Canopy Retention Analysis

Ladera Vineyards Winery
Minor Modification P21-00294-MOD and Viewshed P22-00109
Planning Commission Hearing June 7, 2023

Re: Ladera Vineyards Minor Modification– Response to Napa County comments on biological resources (File # P21-00294)

**Figure 1. Land Cover**

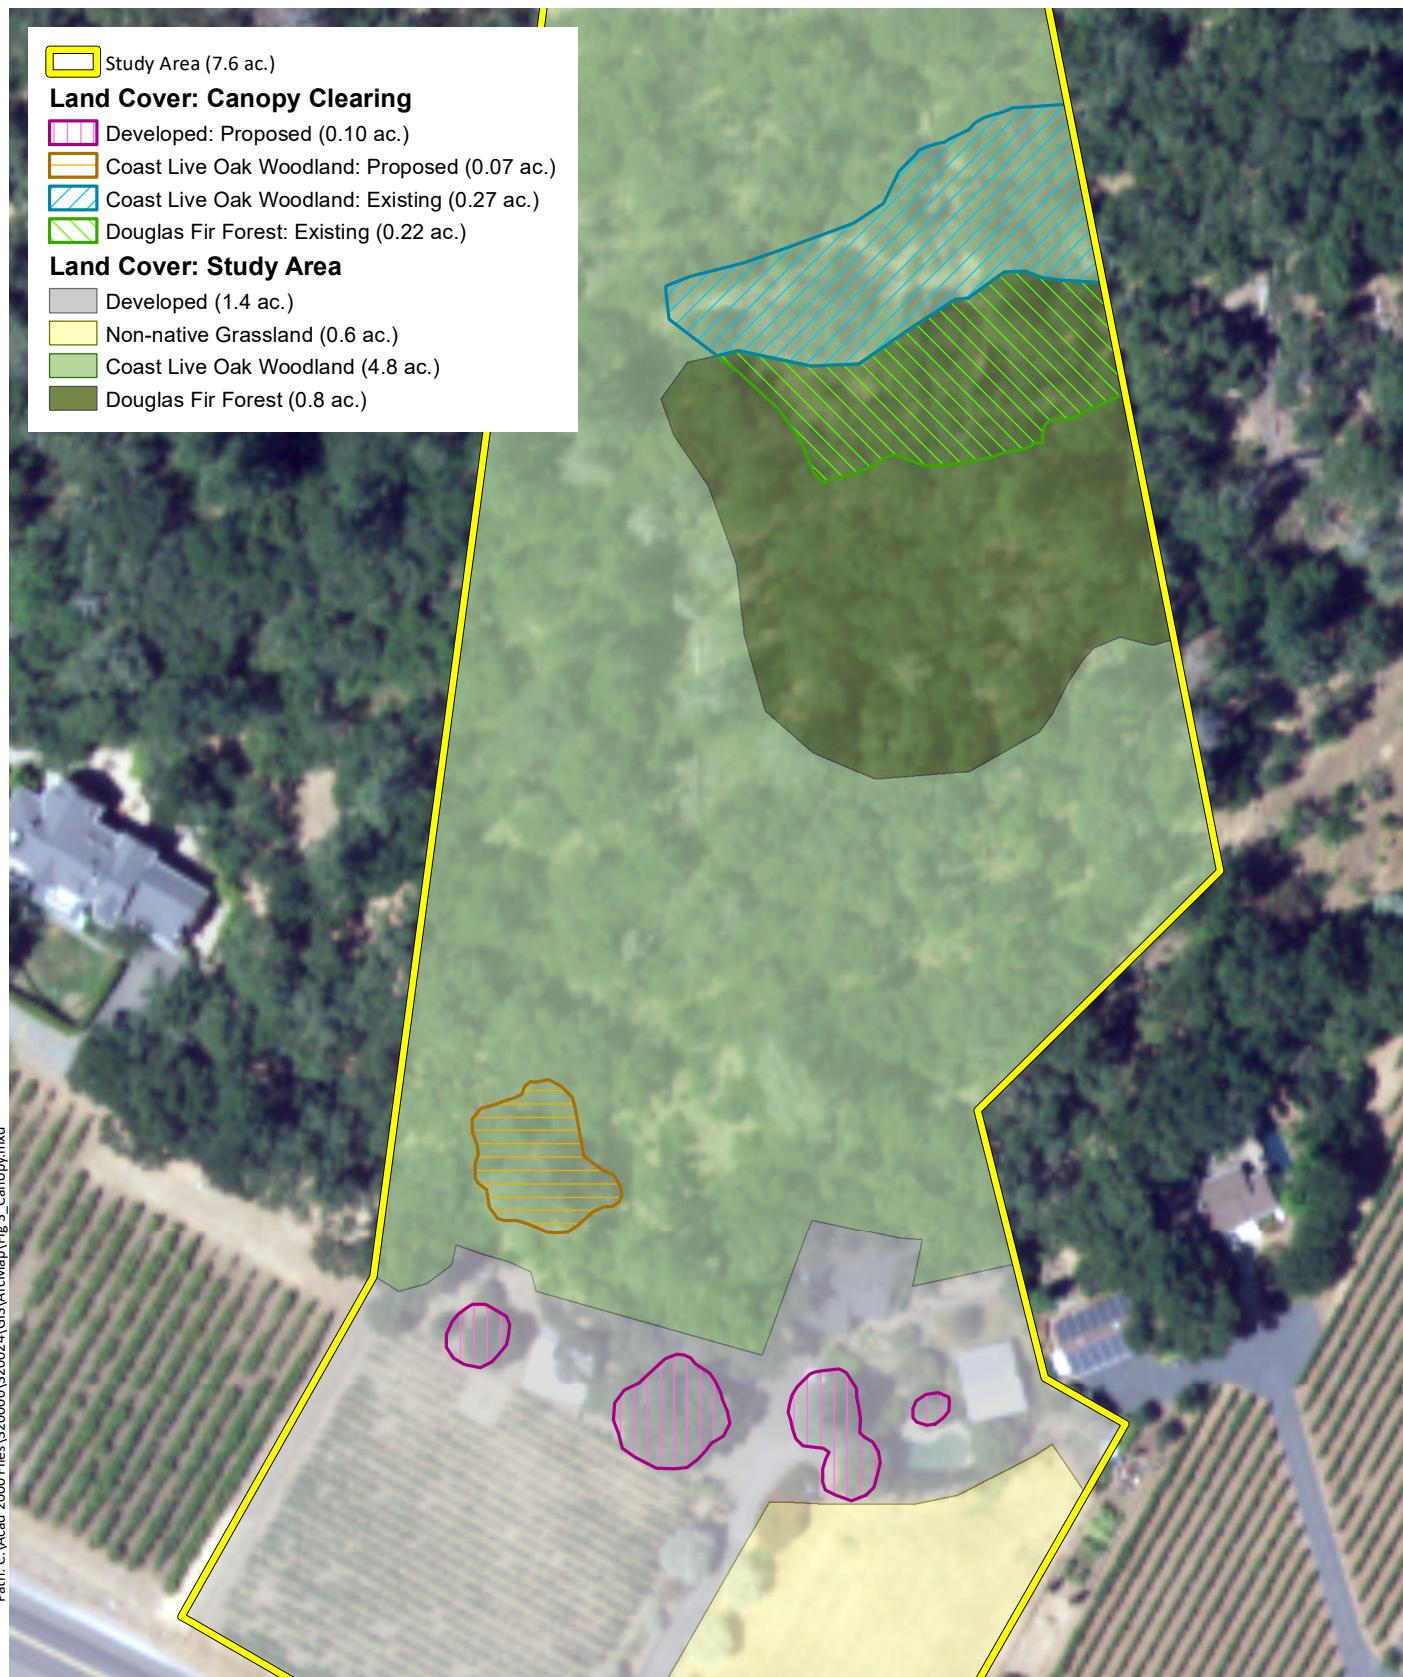
1. Pursuant to NCC Chapter 8.80.135 (Conservation regulations for fire-damaged properties and fire-damaged vineyards), the vegetation canopy cover analysis occurring on a fire-damaged property in the AW shall be based on the existing vegetation canopy cover as configured on the parcel existing on June 19, 2018. . . . Please revise accordingly. (p. 6)

For consistency, a revised land cover figure using a 2018 baseline aerial is included in Attachment A. As suggested in the full version of the County's comment, there are no notable differences in the extent of on-site canopy between the two aerials (2016 versus 2018) and thus WRA's mapping is unchanged.

Figure 2. Canopy Preservation Area

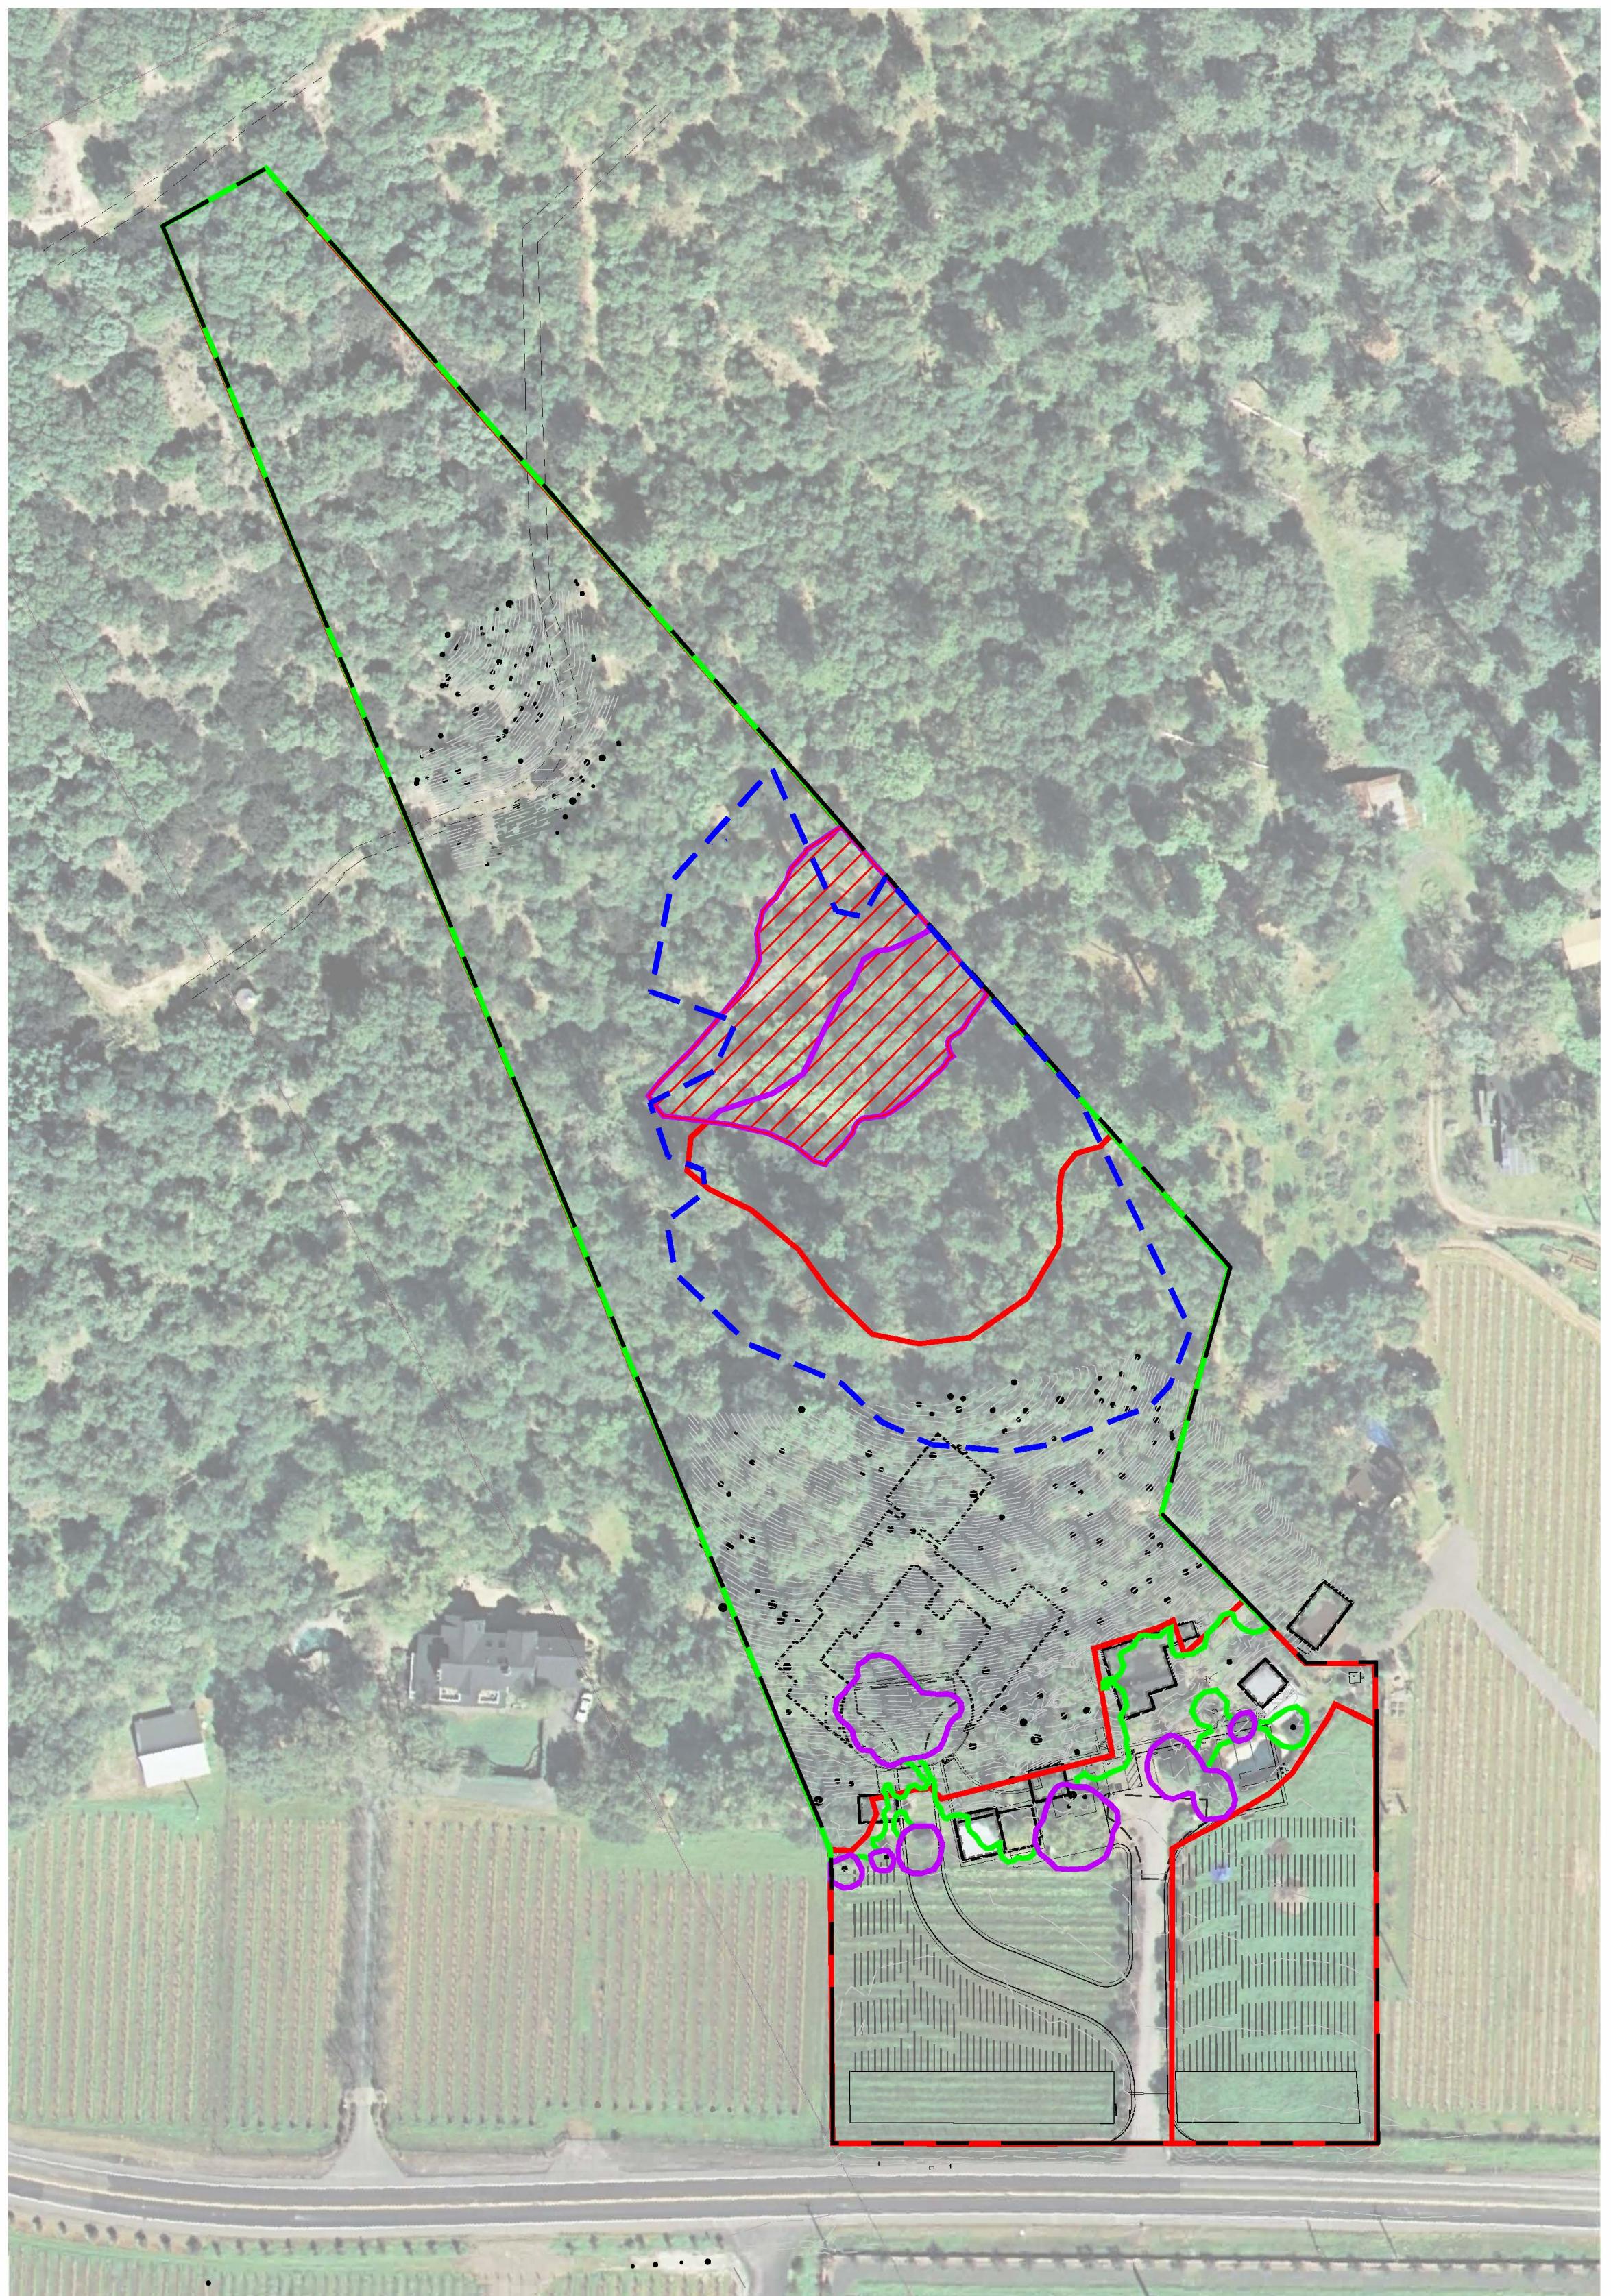
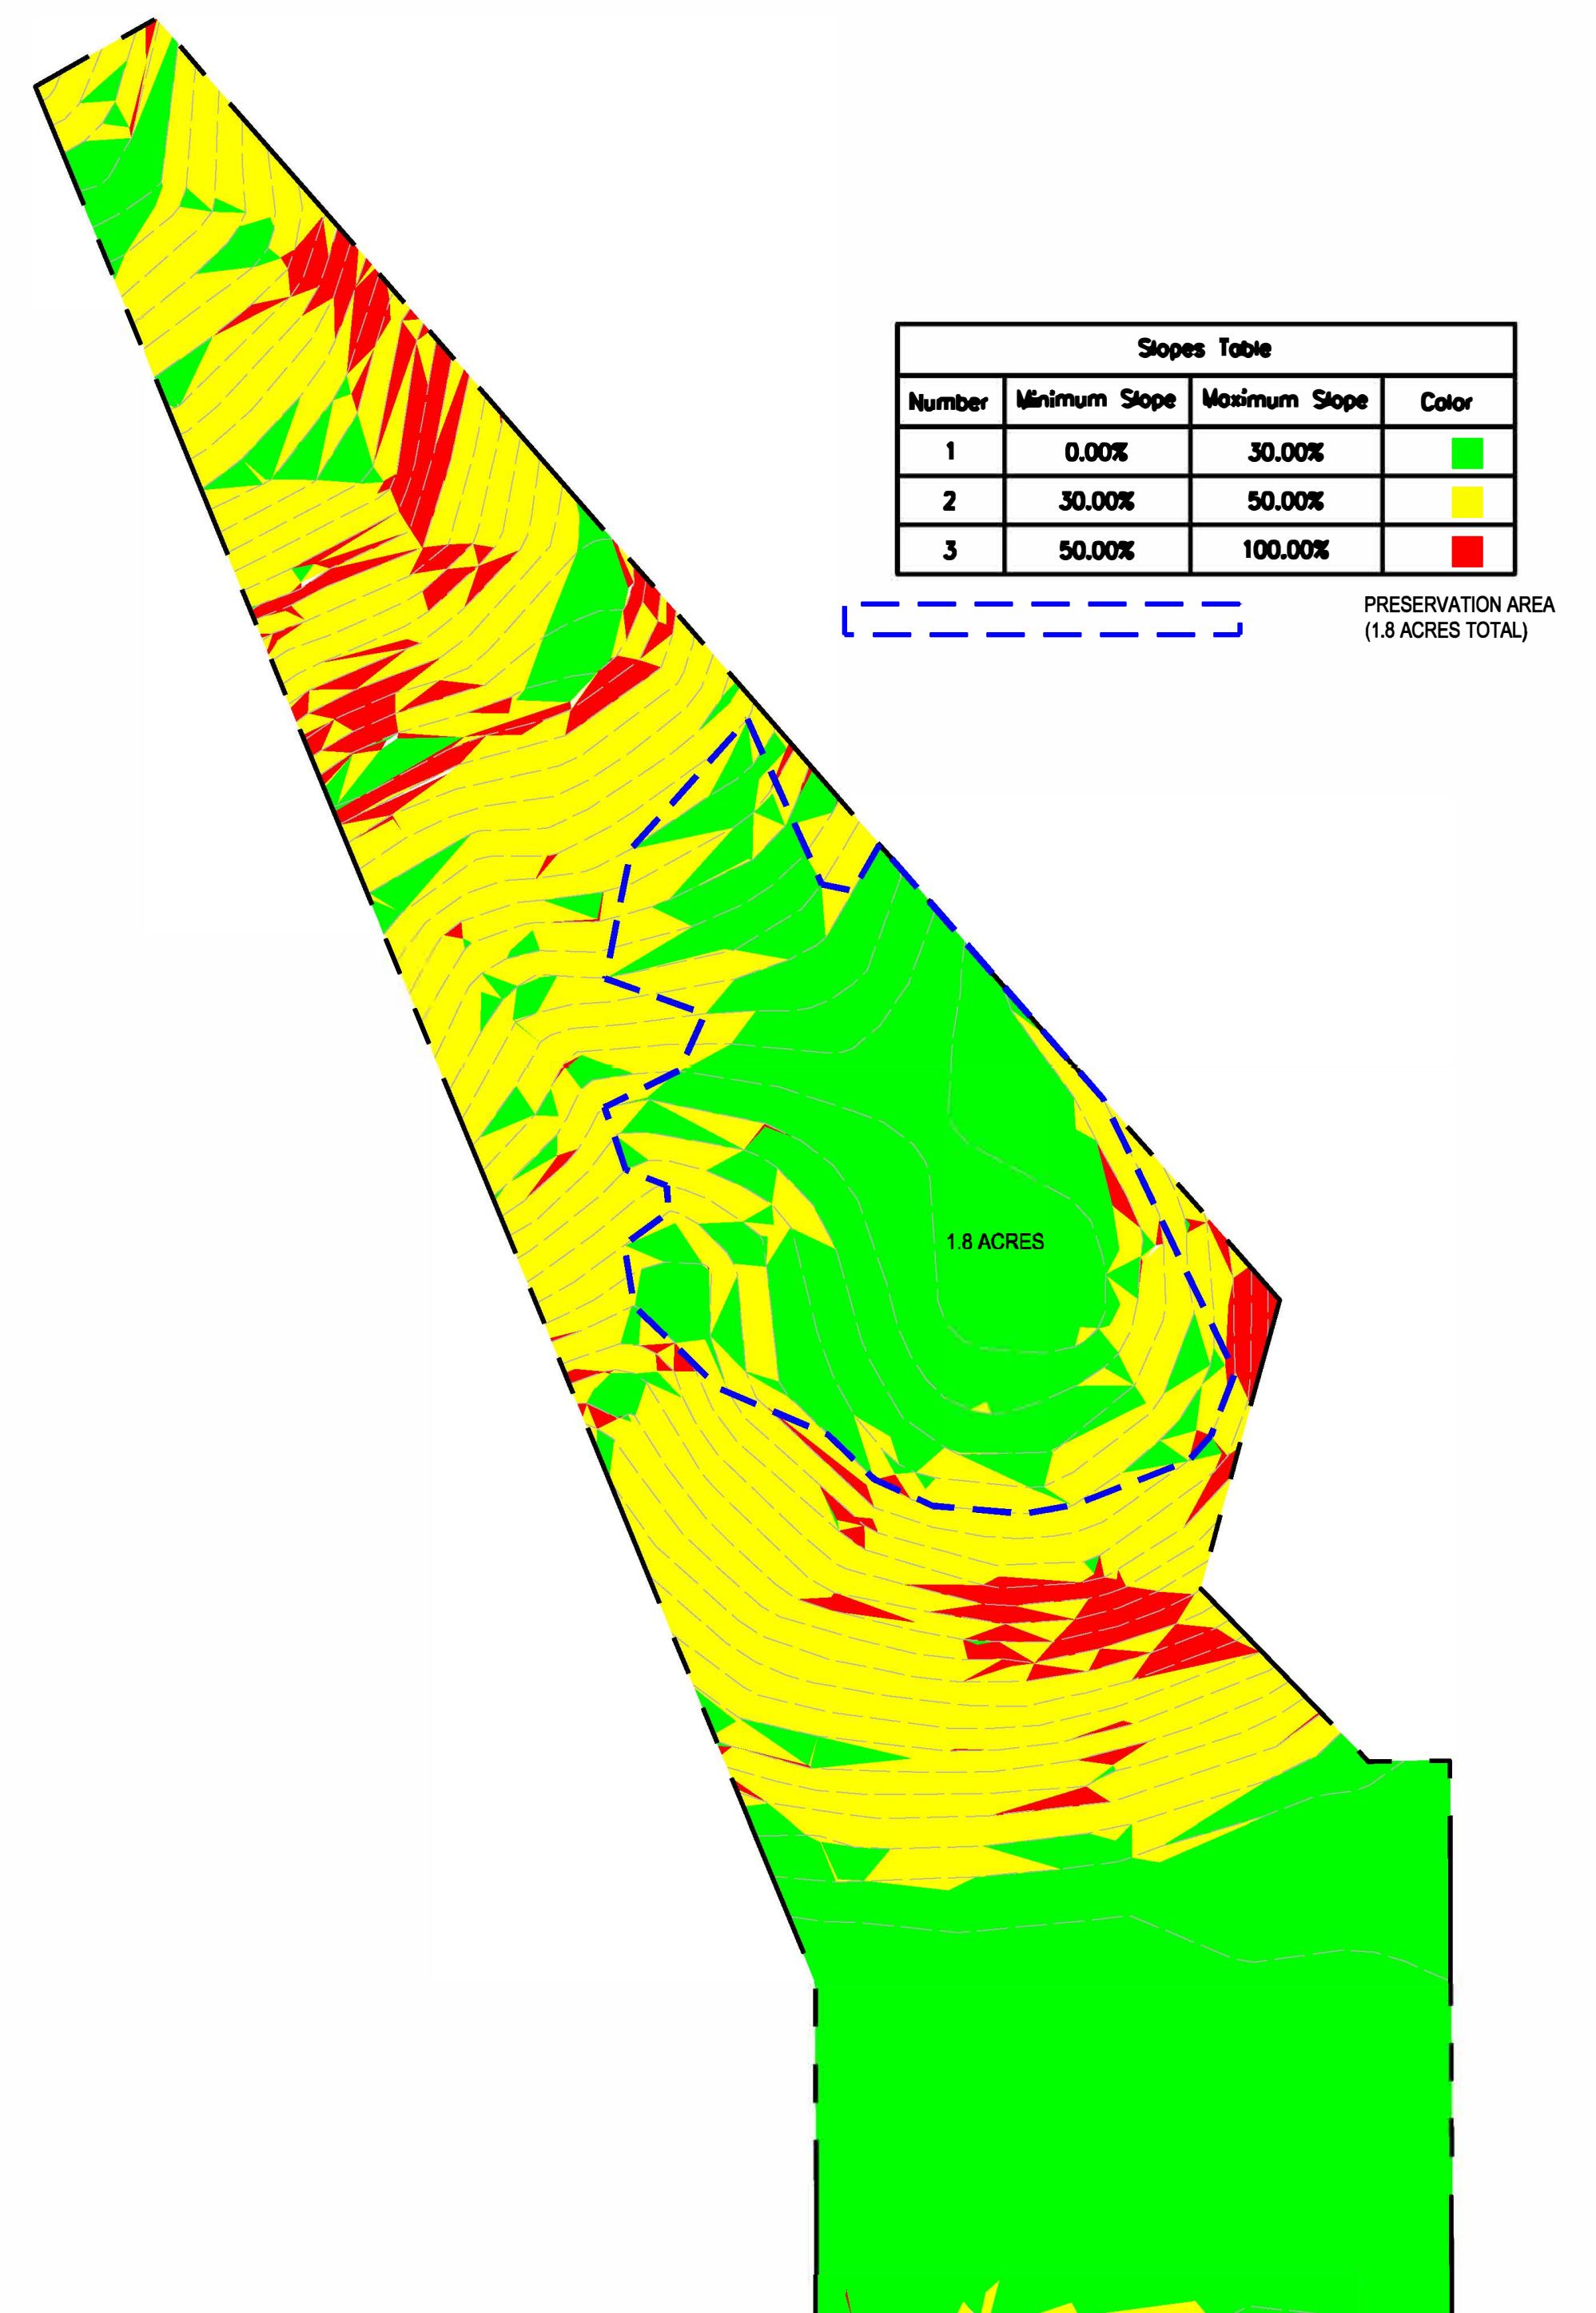
3. NCC Chapter 18.108.020(D) requires that any vegetation canopy cover removed by the project and/or since baseline be mitigated at a 3:1 ratio by acreage. . . However, the same subsection of the code requires that the location of the permanent replacement or preservation be prioritized as listed, including 1) on-site on lands with slopes of 30% or less and outside of stream and wetland setbacks; and 2) if cannot be reasonably accomplished under (D)(1), on-site preservation may occur on slopes up to 50% that results in the highest biological and water quality protections. Please identify the proposed 3:1 mitigation preservation area per NCC Chapter 18.108.020(D). (pp. 6-7)

An area of oak woodland and Douglas fir forest proposed for preservation, overlain with both mapped land covers and percent slope on the property, is shown in Figure 2 (Attachment A). This preservation area has been identified in part via feedback from the County and constitutes the required 1.8 acres. The area is sited to specifically include the largest portion of the property where average slope is 30 percent or less and canopy is currently or was recently present. (There are no wetlands or streams within the Study Area, so avoidance of setbacks to such features are not relevant.)

The proposed preservation area includes the bulk of the approximately 0.5-acre cleared area which featured both Douglas fir forest and oak woodland. Although canopy was removed in this area (after 2018), the substrate was not meaningfully altered, and the area remains surrounded by existing forest/woodland. The area currently supports successional shrubbery, and native trees will presumably naturally recolonize the area over time if allowed to do so. The subject preservation area will feature relatively low perimeter-to-area ratio (reducing exposure of the interior to edges), resulting in one block that is directly contiguous with existing canopy on the property to the east.

It is WRA's understanding that this will be formally protected by a deed restriction or similar mechanism that is acceptable to the County. Formal protection should specify the ultimate preservation goal of supporting renewed canopy.
